AGENDA PLANNING COMMISSION MEETING

April 16, 2026 - 6:00 PM
City Hall Council Chambers

Progressive, LLC is proposing development of 51 dwelling units on 21.3 acres of land located at the southwest corner of Kenwood Avenue (CSAH 50) and Ipava Avenue. The proposed development requires consideration of applications for a Comprehensive Plan amendment guiding the property for a single residential land use category; Zoning Map rezoning portions of the property to RST-2 District; a Conditional Use Permit for Planned Shoreland Development; Preliminary Plat; and Vacation of existing public right-of-way.

PRELIMINARY SITE PLAN

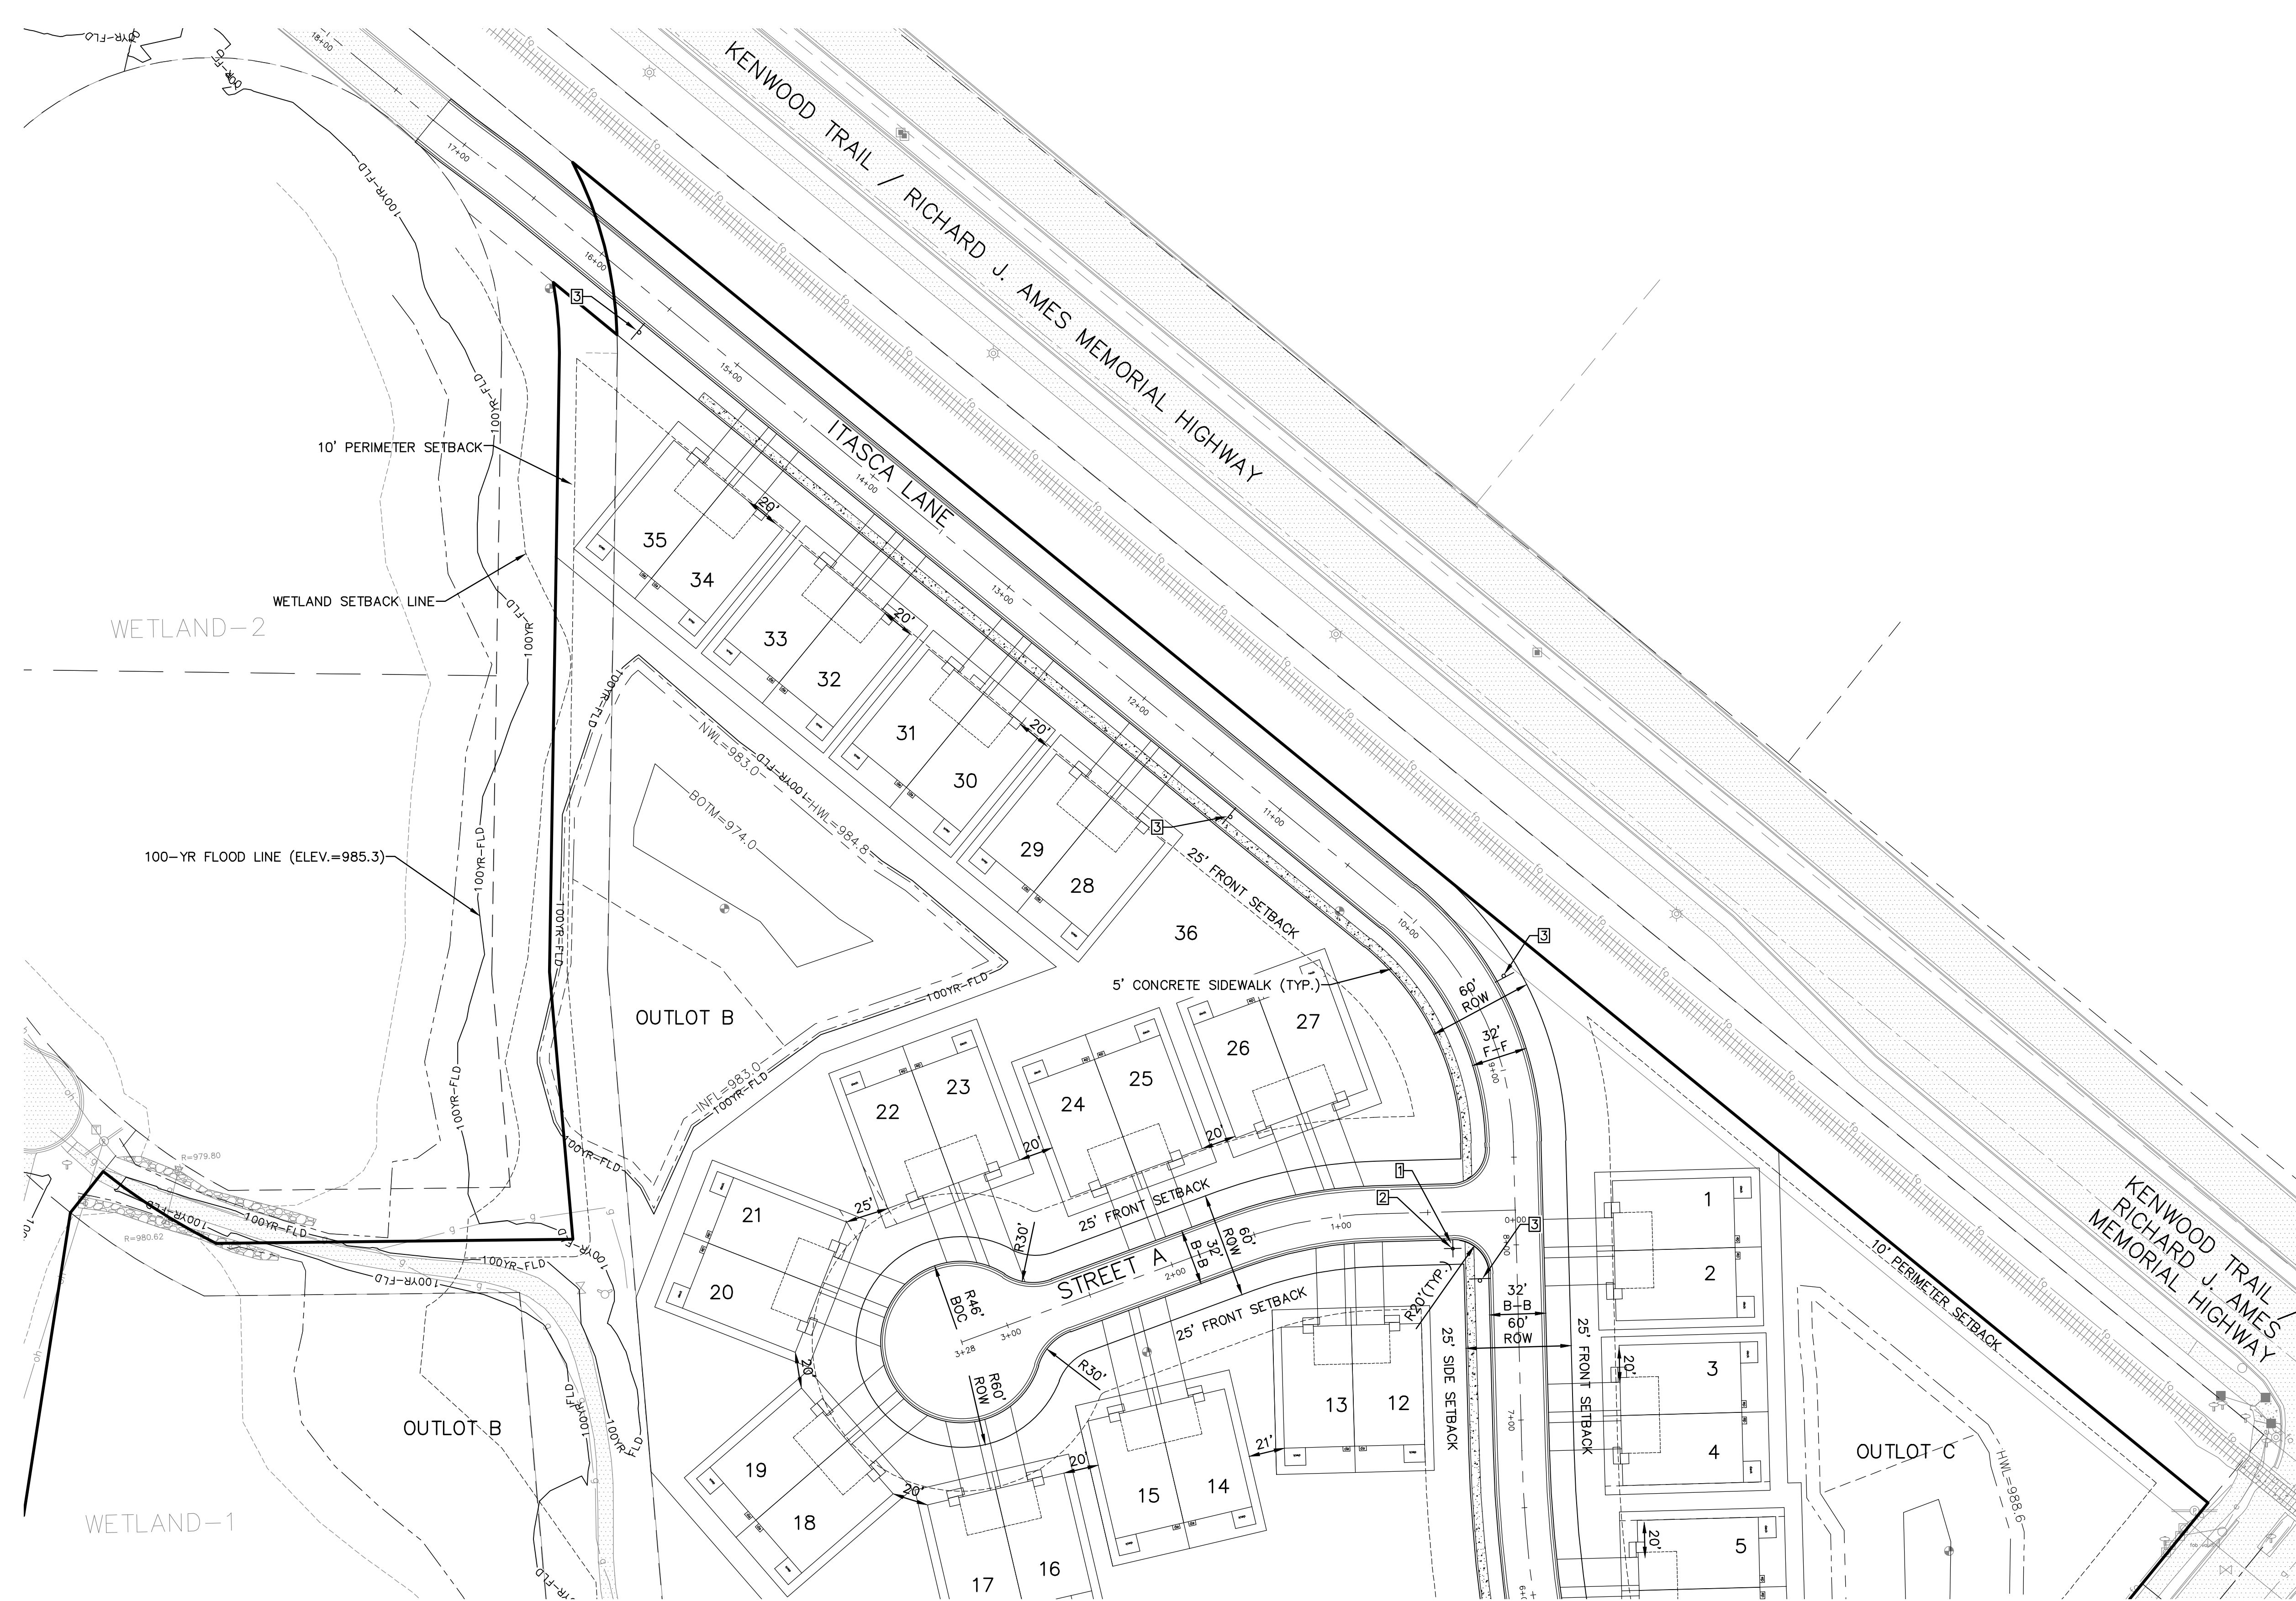
Setbacks. The table below summarizes the setbacks required for the dwelling units within Blocks 1 and 2 of the proposed preliminary plat. The setbacks shown on the preliminary site plan (Sheets 5.01 and 5.02) for the detached townhomes and twin homes comply with the RST-2 setback requirements.

LANDSCAPE PLAN

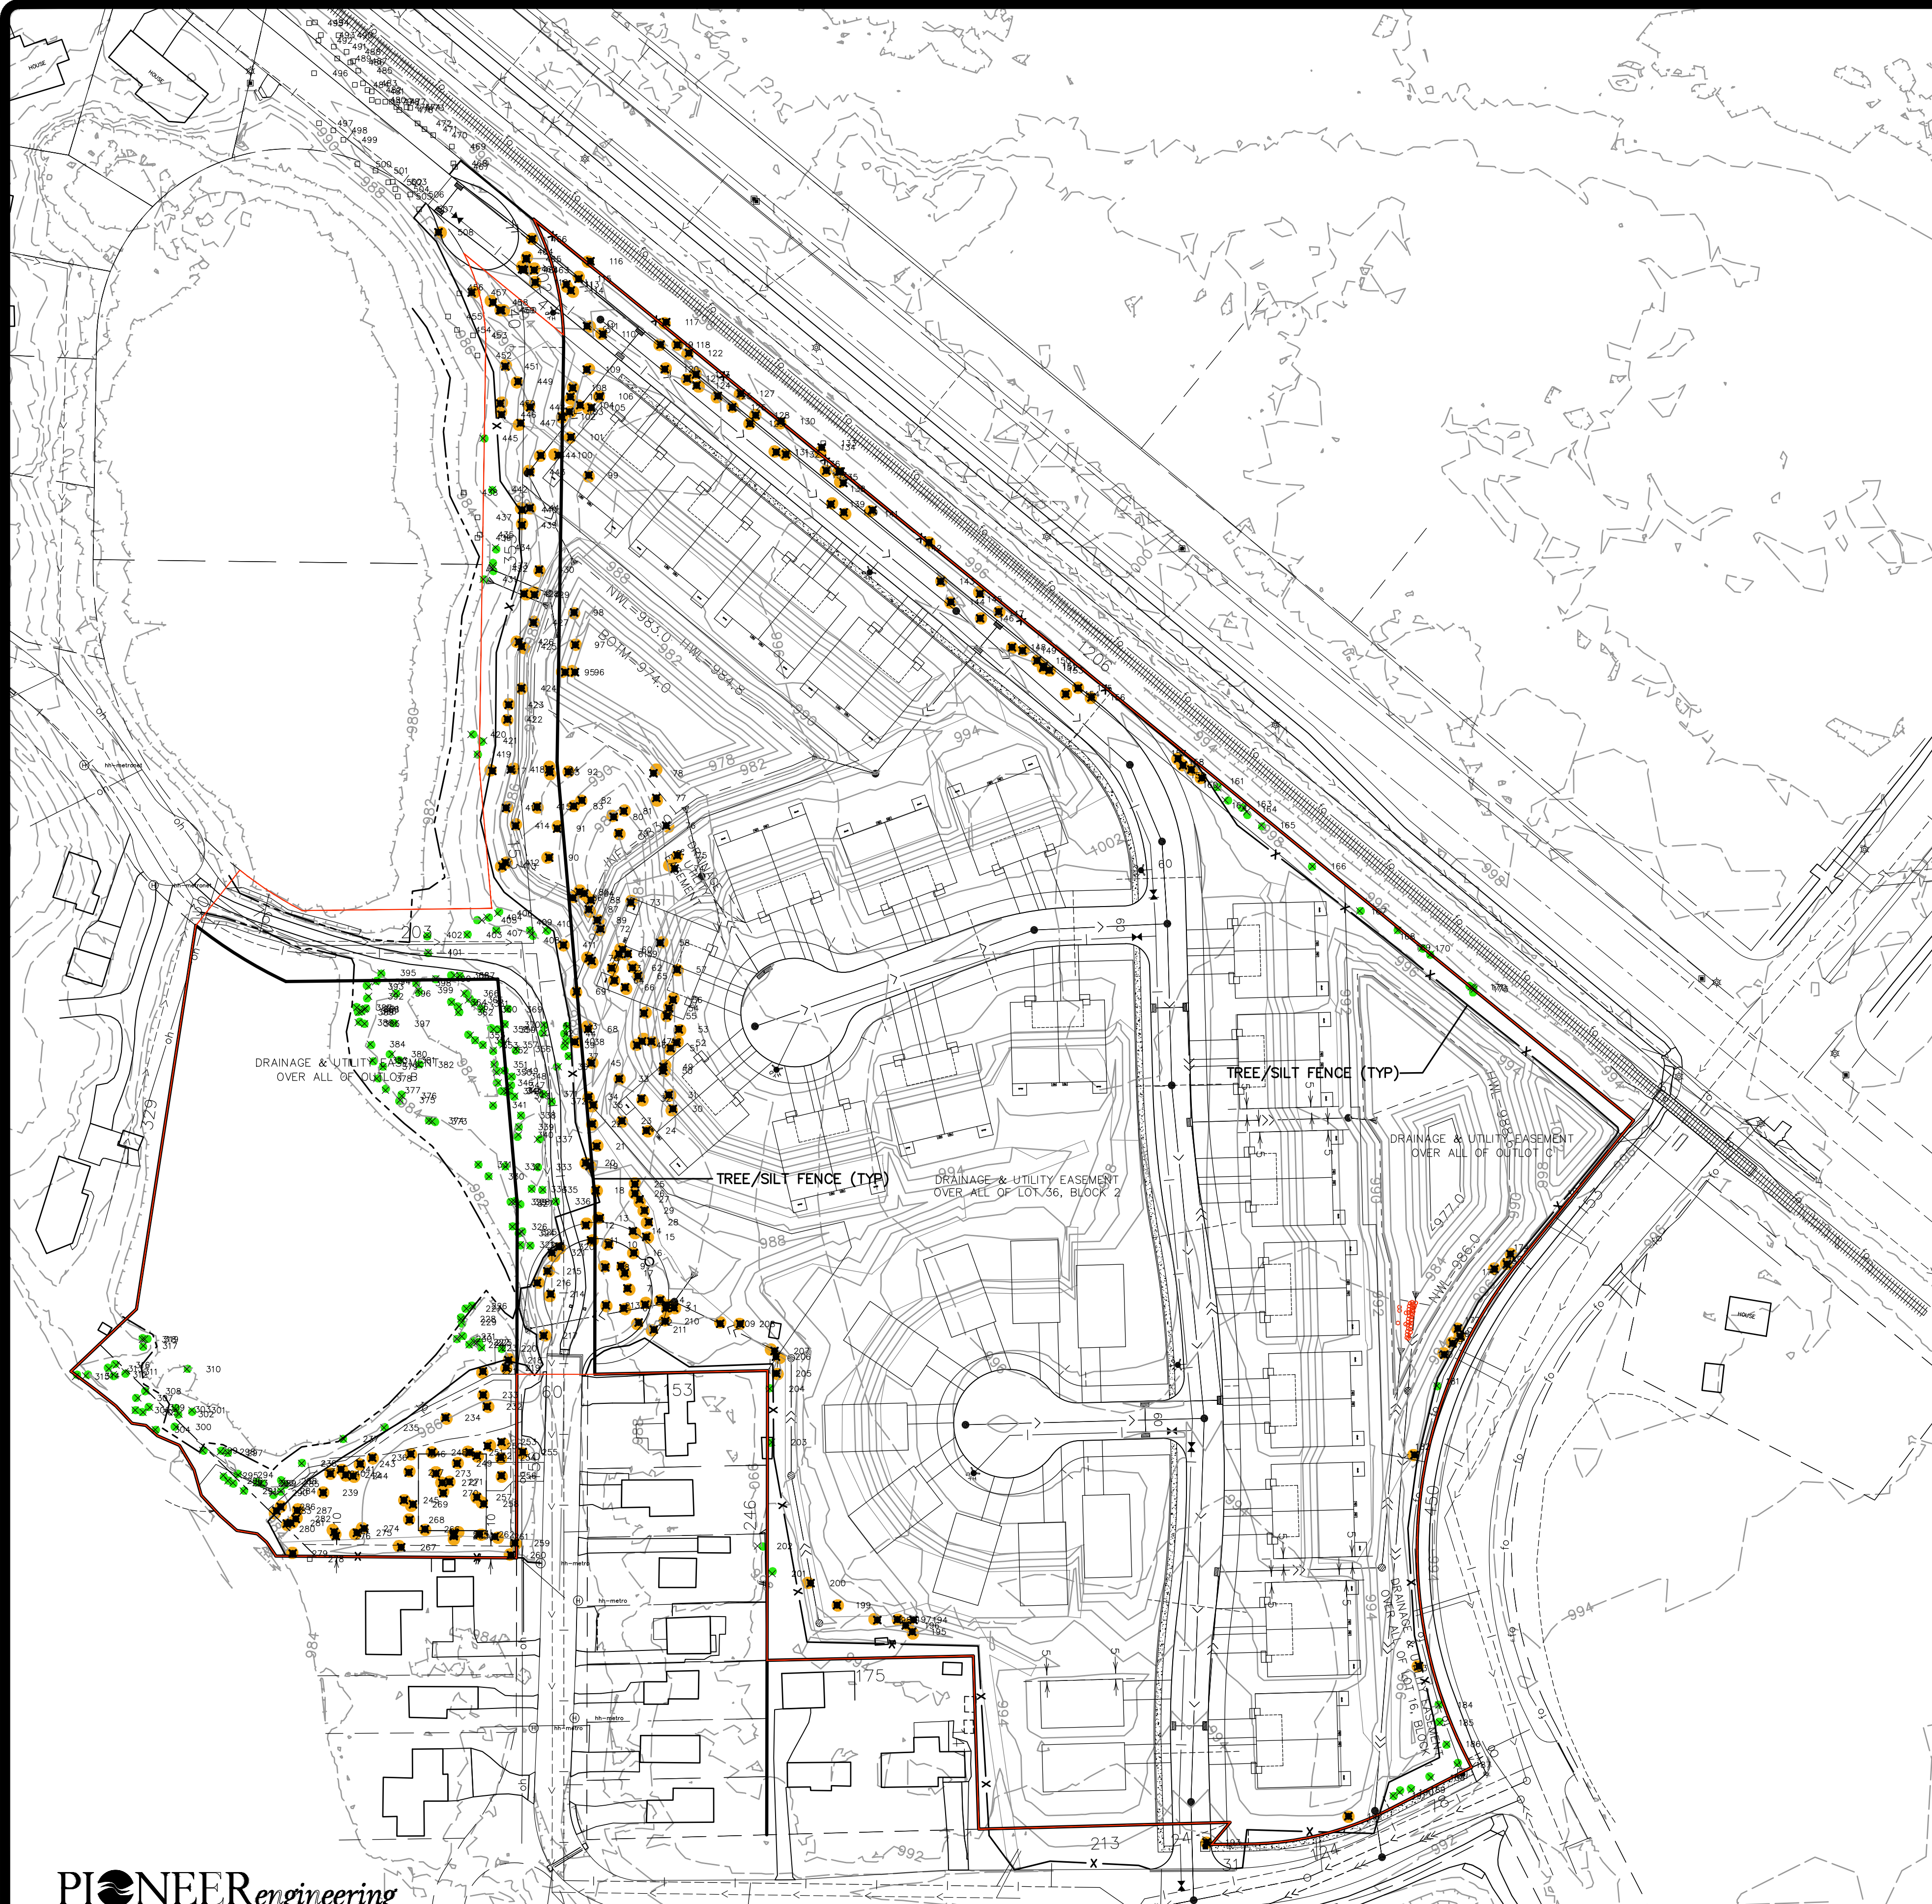
Landscaping. Section 11-57-19.G of the Zoning Ordinance establishes landscape standards for detached townhome and twin home uses within the RST-2 District. A landscape plan has been submitted for the proposed preliminary plat and the City Forester is recommending providing additional tree planting west of Lots 6 and 7, Block 2 to screen from existing houses. The landscape plan must also be revised to provide residential buffer yard planting east of Lots 11-16, Block 1 as required by Section 11-21-9.E of the Zoning Ordinance.

- a. Provide additional tree planting west of Lots 6 and 7, Block 2 to screen from existing houses.
 - b. The landscape plan shall be revised to provide residential buffer yard planting east of Lots 11-16, Block 1 as required by Section 11-21-9.E of the Zoning Ordinance.
